ADDENDUM No. 1

Temporary Fire Station No. 2
Tenant Improvement

PROJECT NO. 3447

Date: November 7, 2019

Drawing No. E-102
Sheet No. ____ of ____

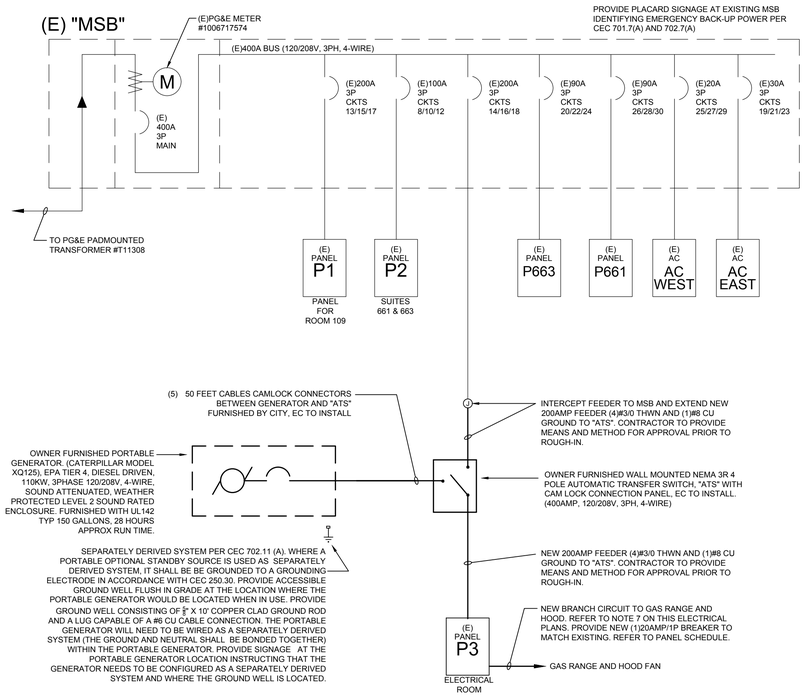
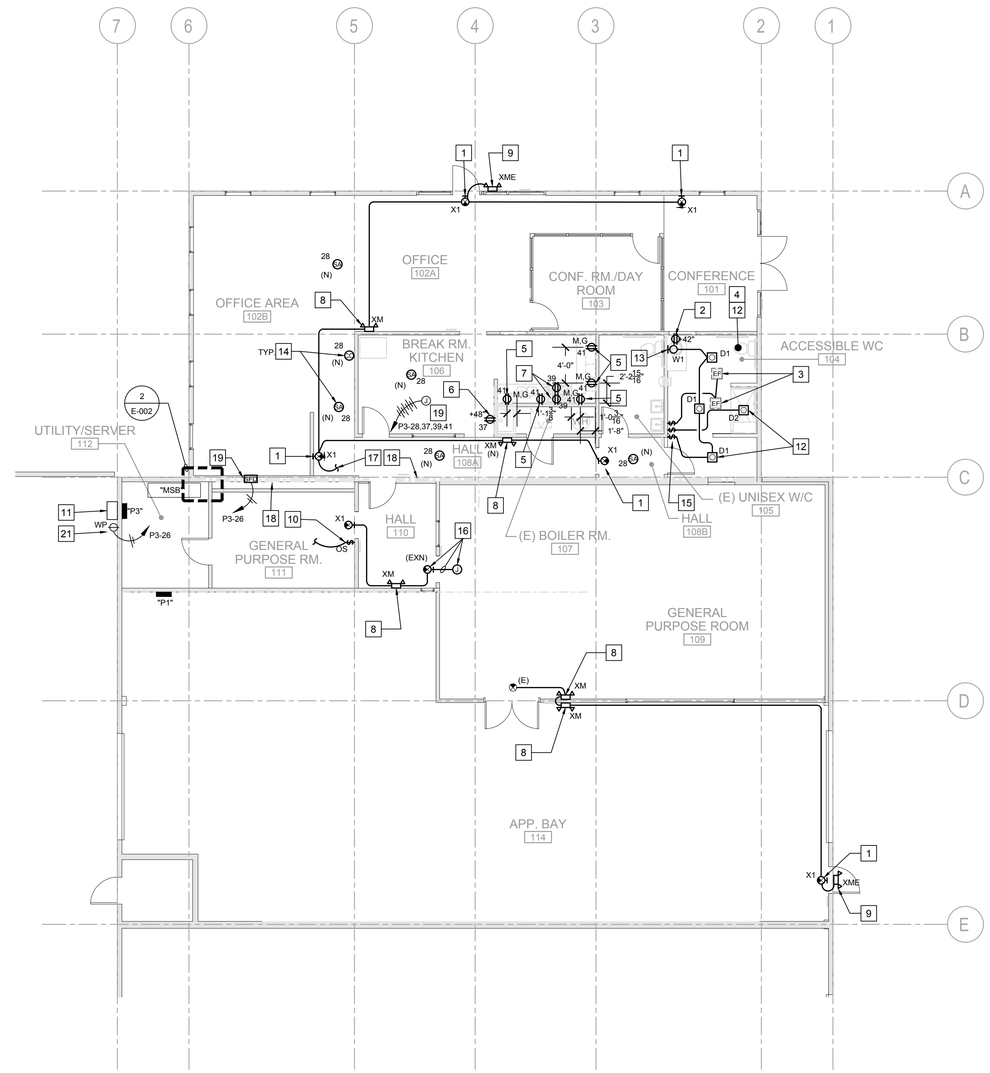
4. Drawing Revision: Replace sheet E-102 entirely with the attached revised drawing as shown on Exhibit B. The modifications include, but not limited to:
    a. Provide power to the fire/smoke damper. See note #19
    b. Provide 30-amp circuit for portable generator battery charger and block heater. See note #21

19. CONNECT TO 120V SMOKE FIRE DAMPER PER MECHANICAL PLANS. PROVIDE NEW HOMERUN TO PANEL P3 WITH 3/4"C (2)#12 AWG AND (1)#12 CU GROUND.
20. NEW BRANCH CIRCUIT HOMERUN TO PANEL P3 FOR REFRIGERATOR, STOVE, KITCHEN APPLIANCES, AND SMOKE ALARM. REFER TO PANEL SCHEDULE. PROVIDE 3/4"C. (EMT) WITH (8)#12 THHN AND (1)#12 CU GROUND.

21. PROVIDE A 30AMP, 125V NEMA L5-30 FOR PORTABLE GENERATOR BATTERY CHARGER AND BLOCK HEATER. PROVIDE WHILE USE COVER. PROVIDE 1/2"C (EMT) WITH (2)#10 THHN AND (1)#10 CU GROUND

EXHIBIT C: EXISTING PENETRATION AT EXISTING 1 HR. RATED WALL

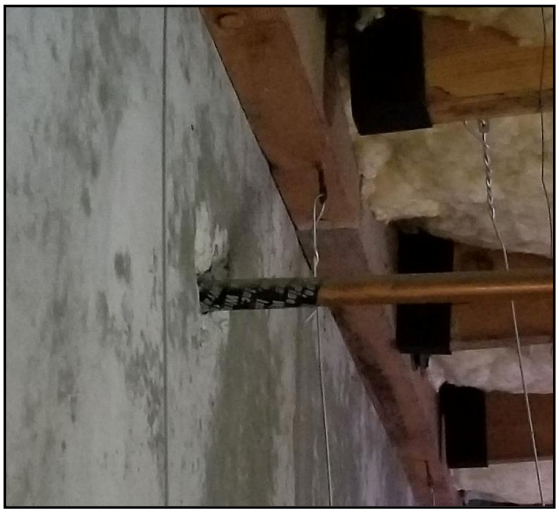
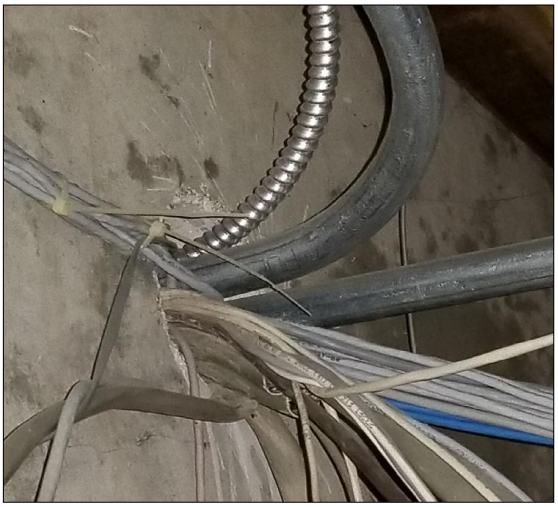
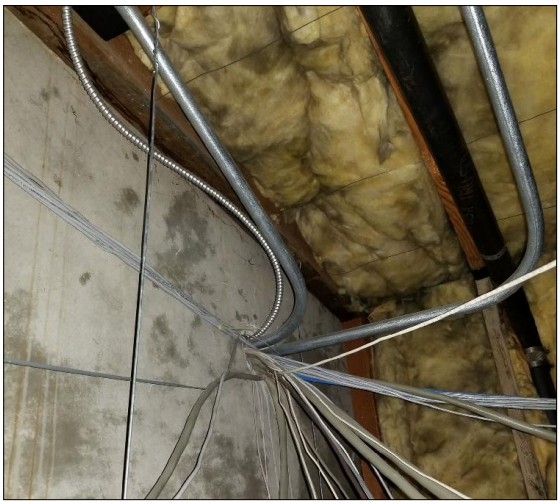
5. For information: Enclosed are pictures of concrete wall penetrations that require the installation of firestopping system or/and Fire/smoke damper. See Exhibit C
